LOT 4, OWL MARKETPLACE

GRADING & EROSION CONTROL DOCUMENTS

ISSUE	DATE
INITIAL ISSUE	10/21/2024
2ND SUBMITTAL	12/12/2024
DESIGNED BY:	CGH
DRAWN BY:	CGH
CHECKED BY:	KGV
FILE NAME:	21611-03-ECCV

COVER SHEET

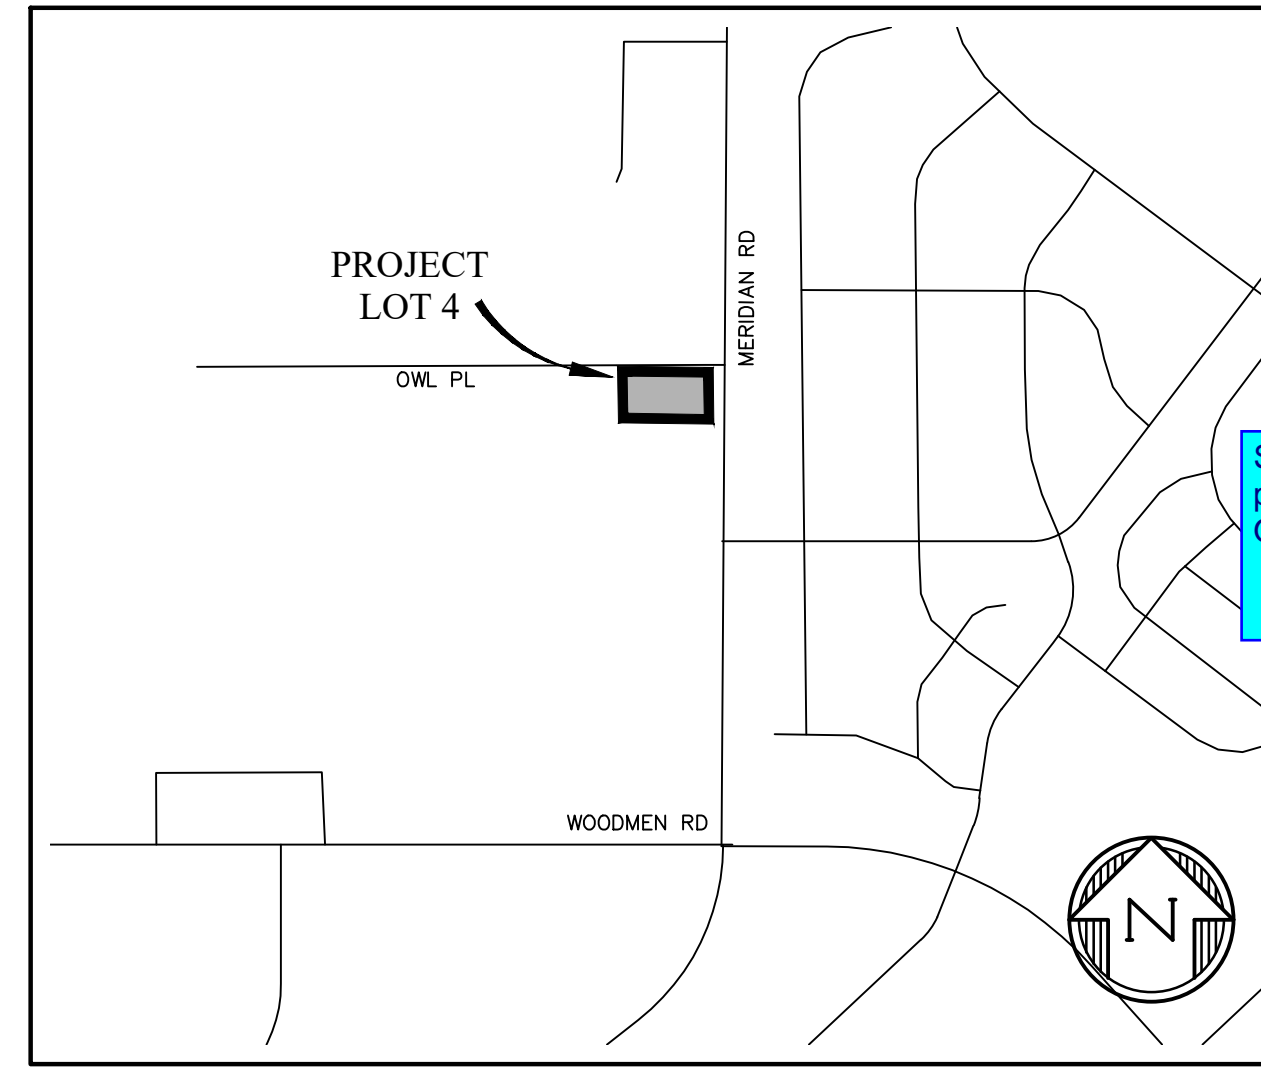
Signatures and ENGR stamp on all pages
Owner signature

**INITIAL GRADING
& EROSION
CONTROL PLAN**

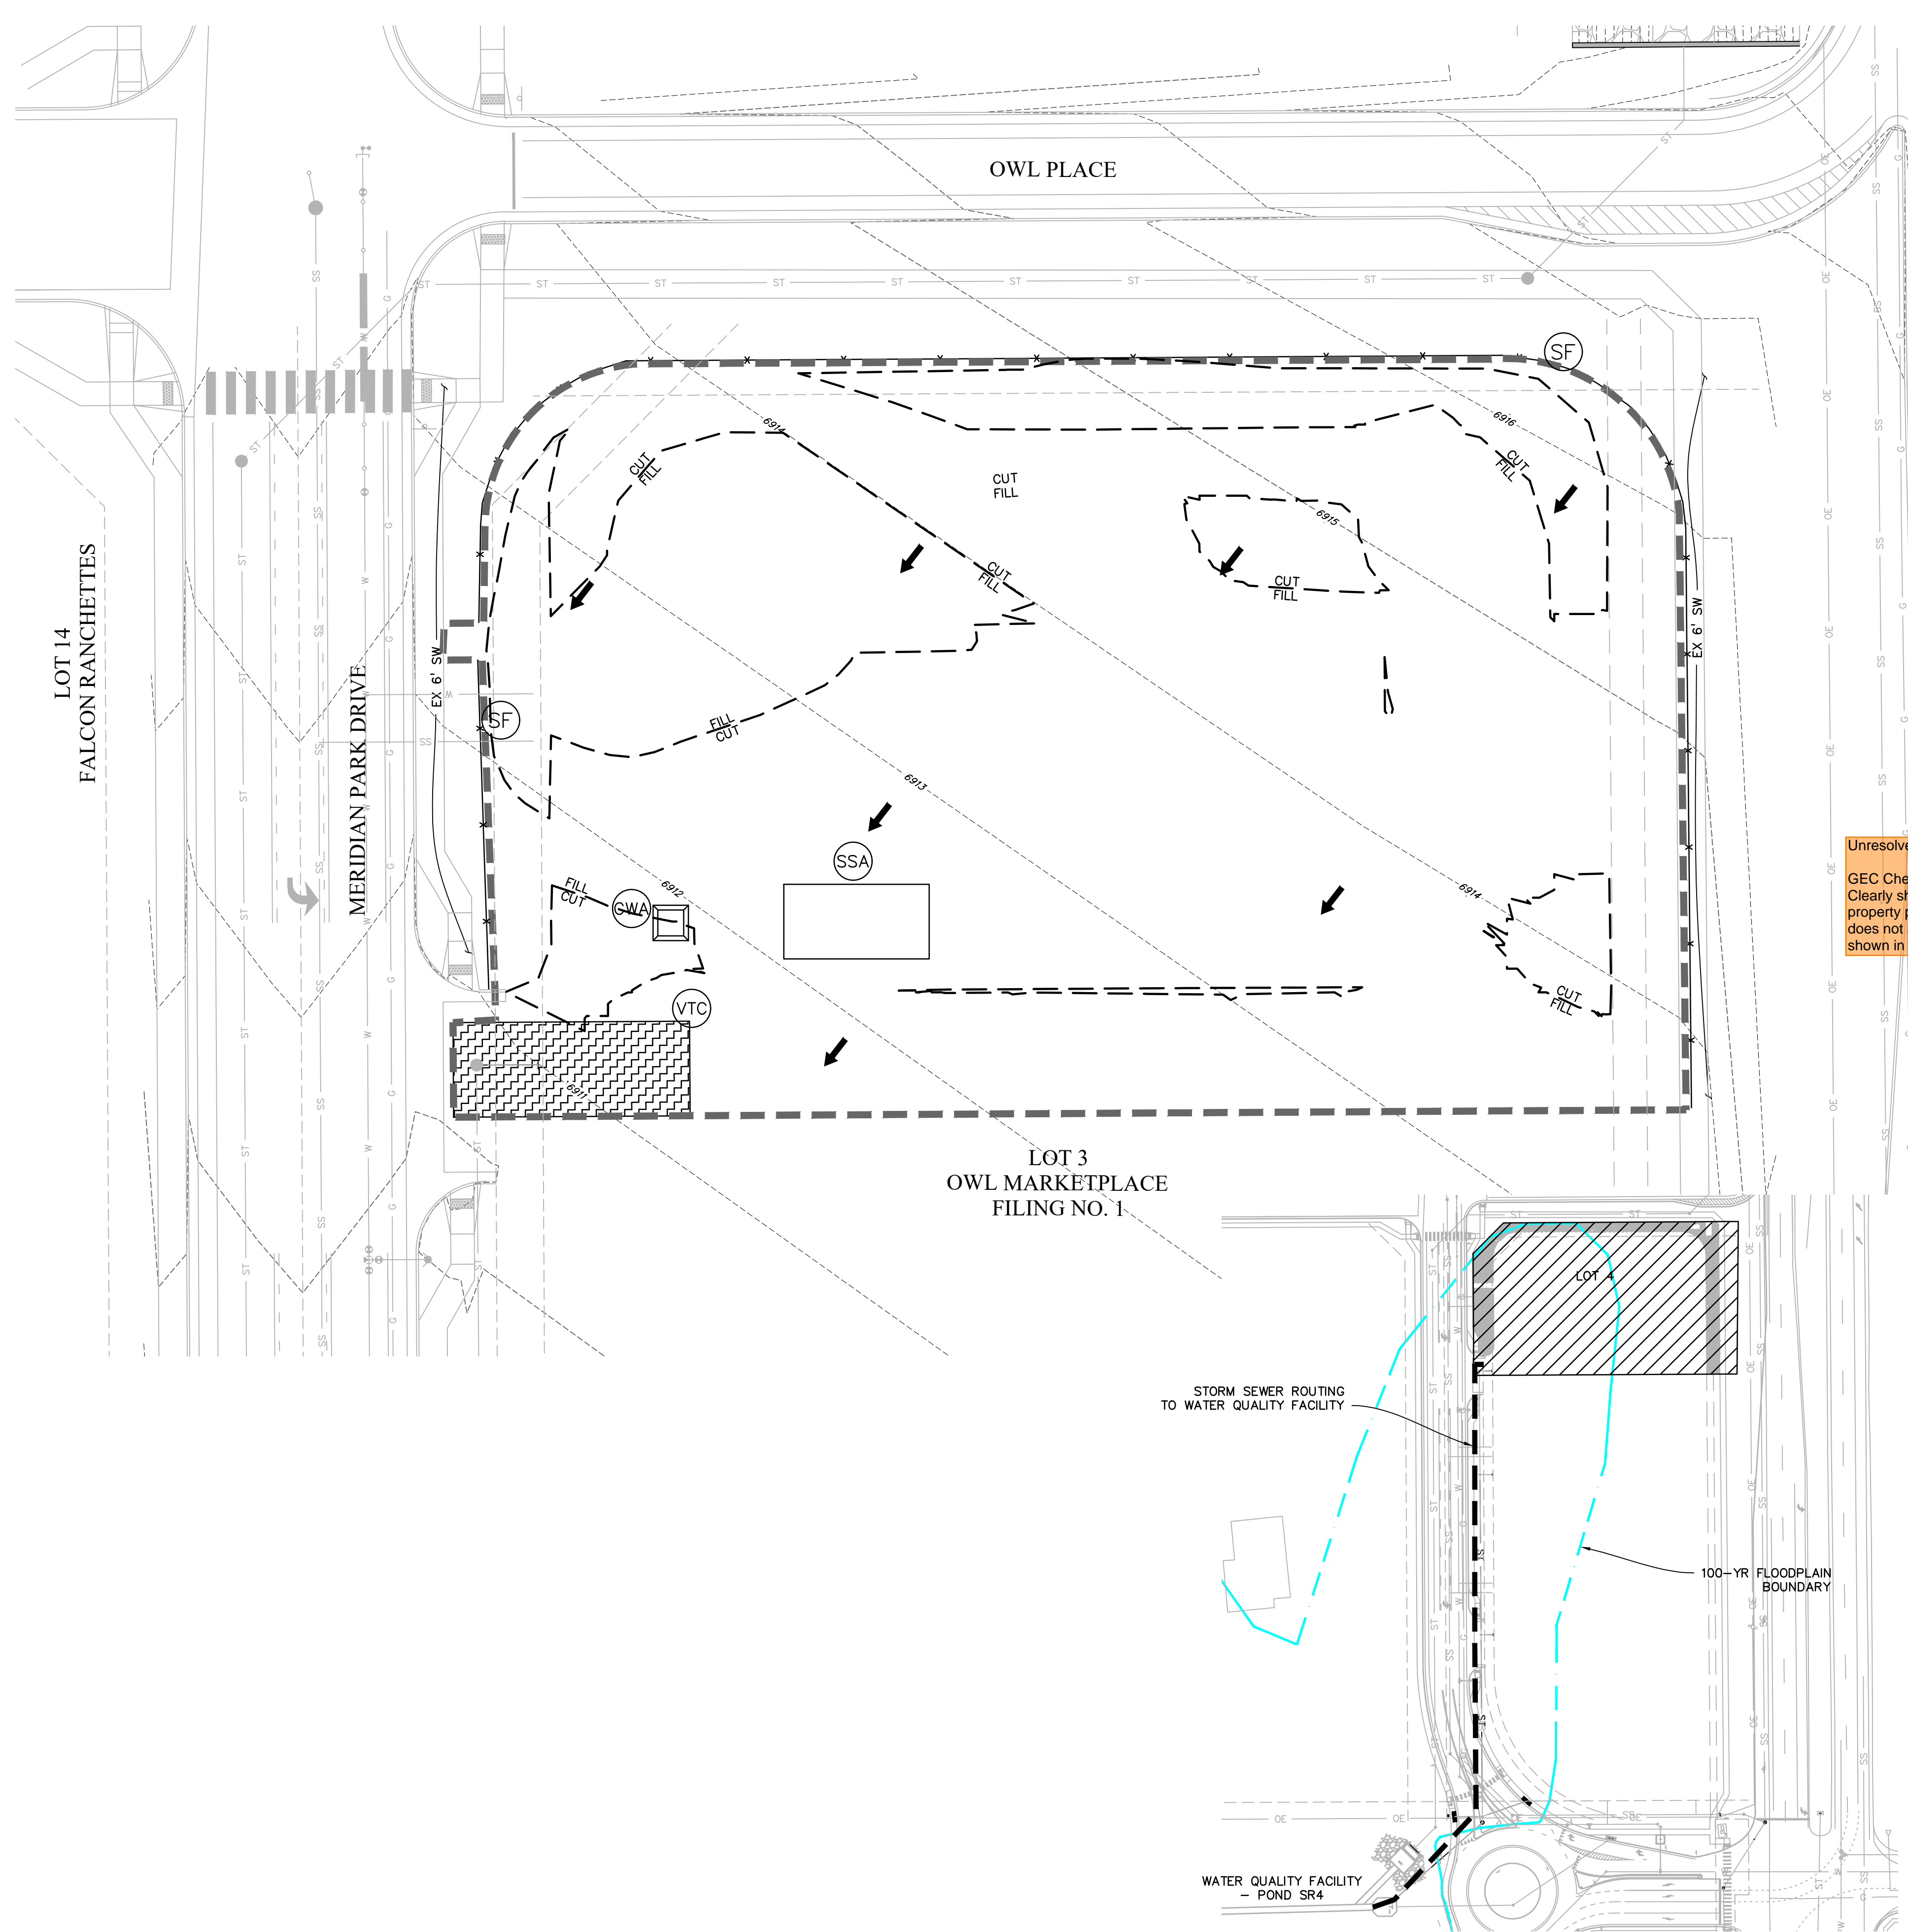
Unresolved comment from Review #1:
GEC Checklist Items b and e:
Clearly show property line and provide
property parcel numbers. The plan view
does not appear to use the linestyle as
shown in the legend.

INTERIM/FINAL GRADING & EROSION CONTROL PLAN

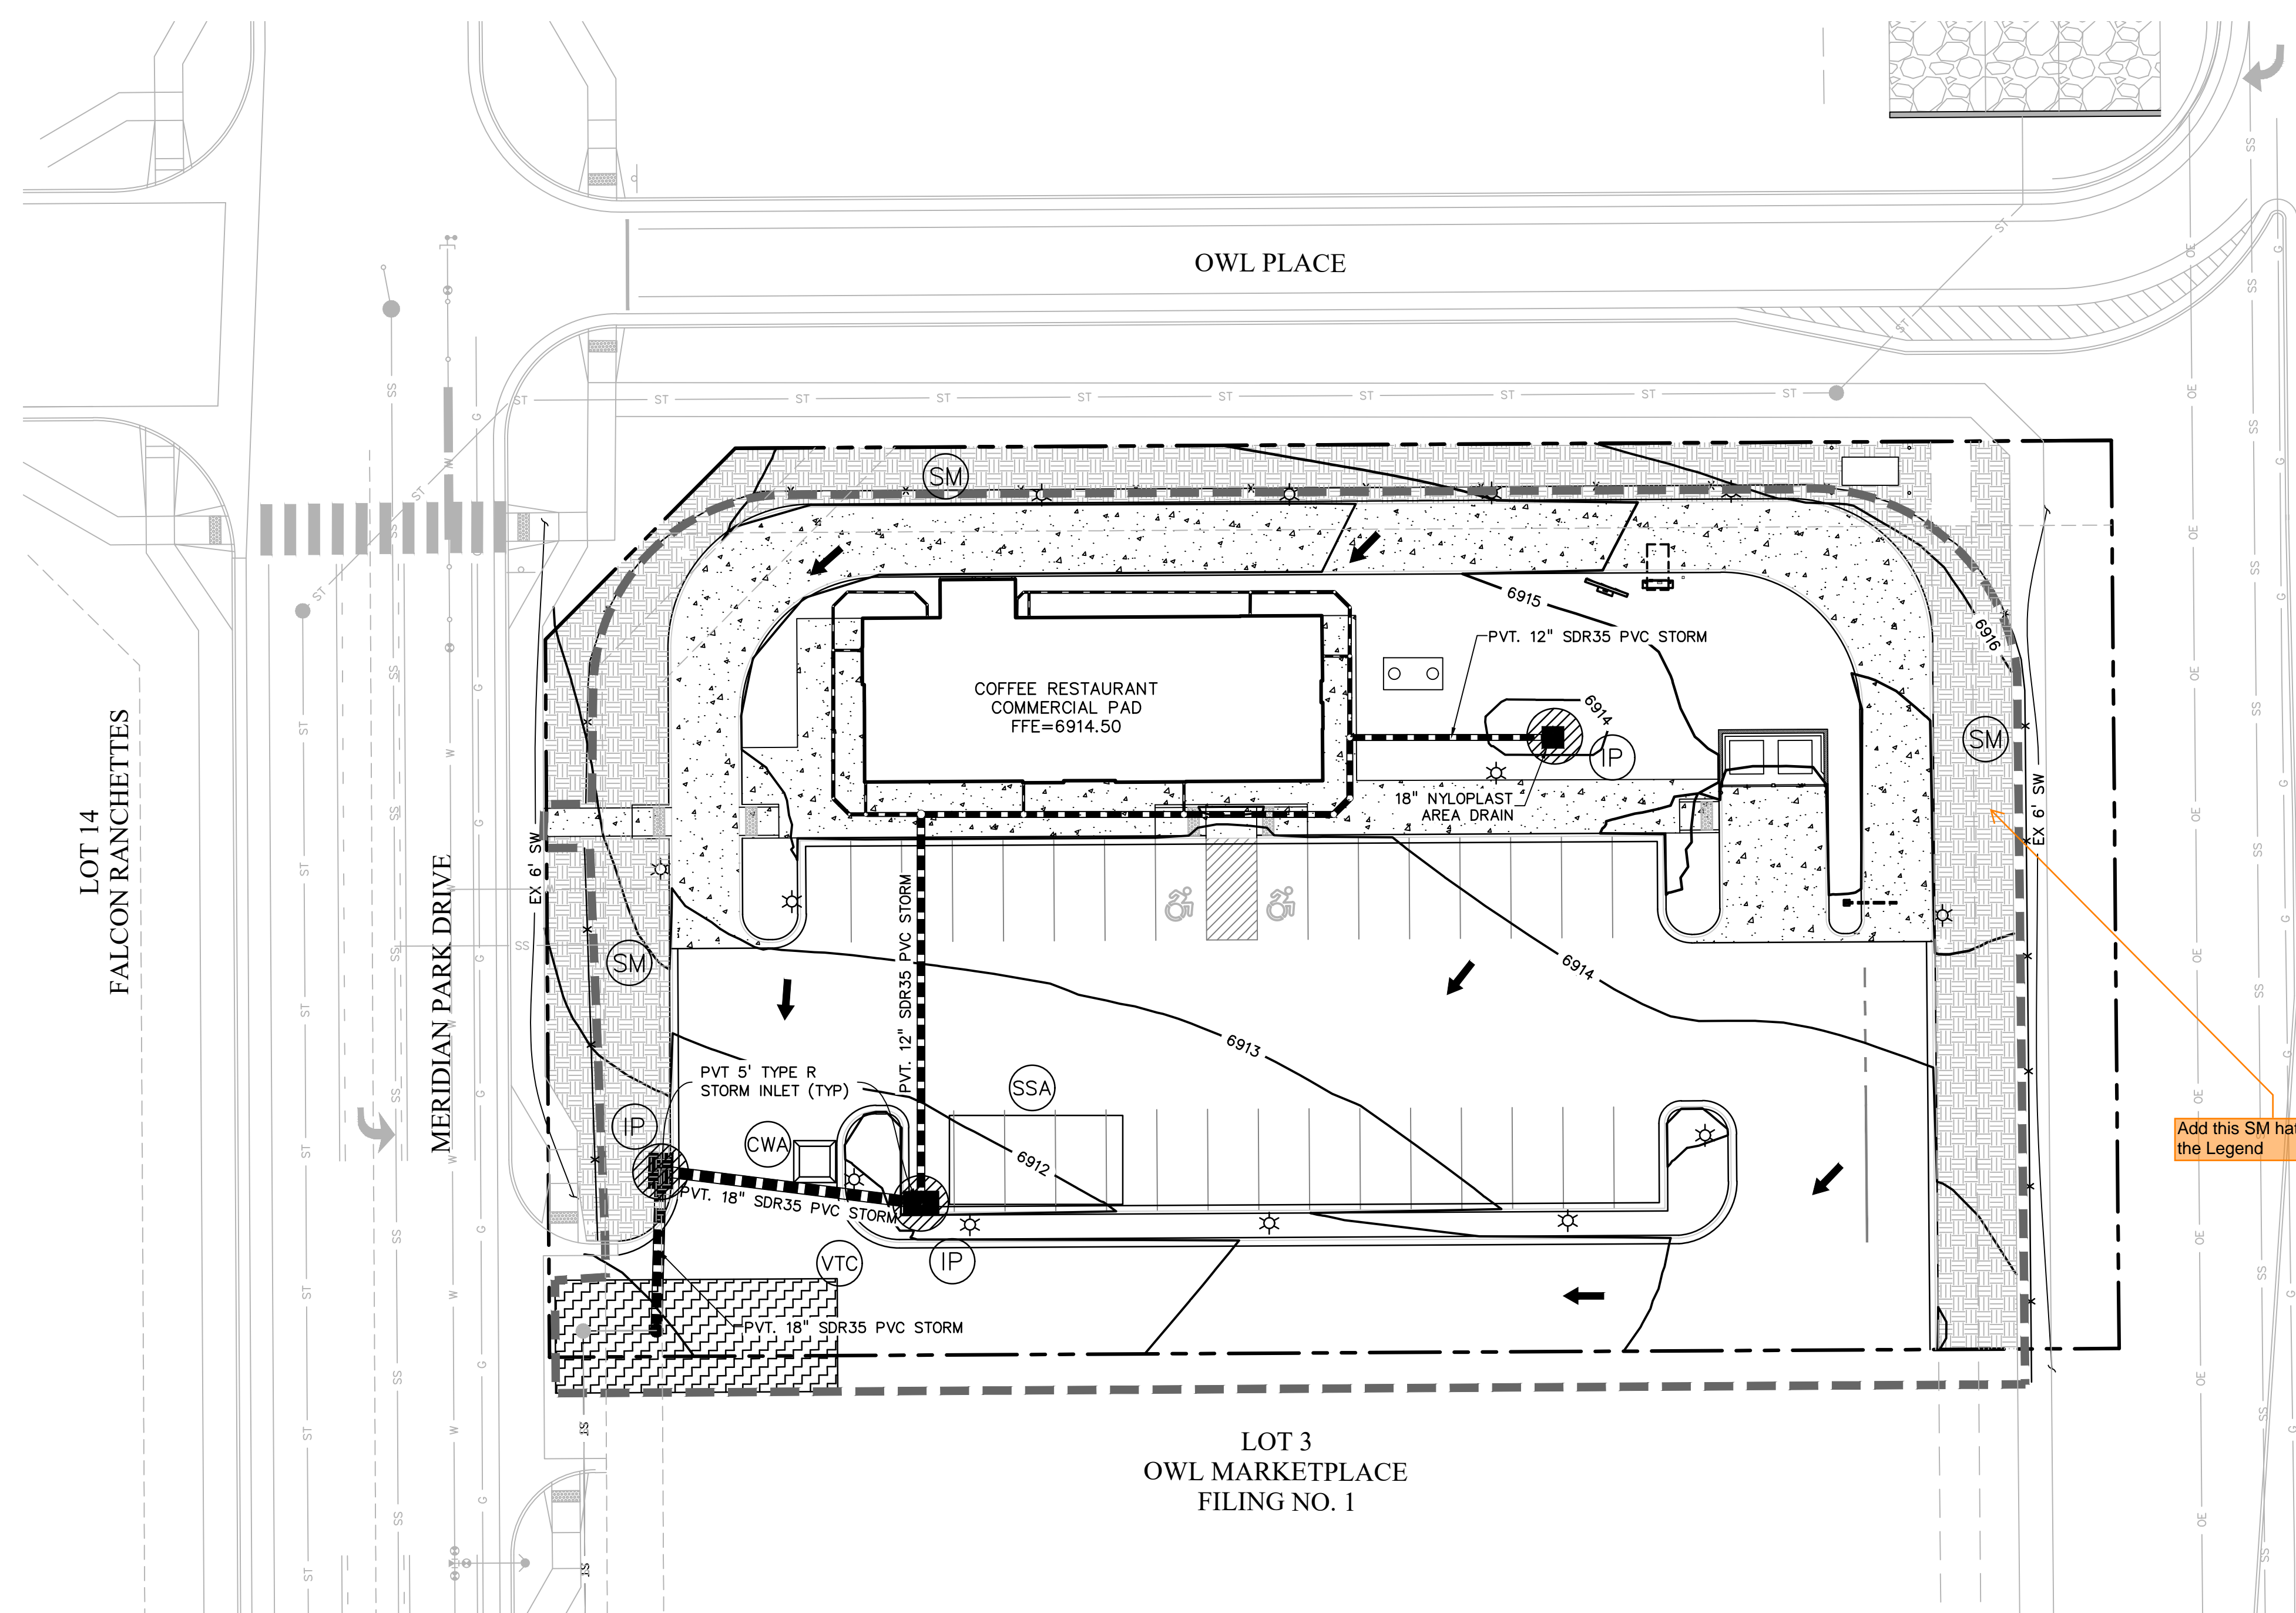
Add this SM hatching to the Legend
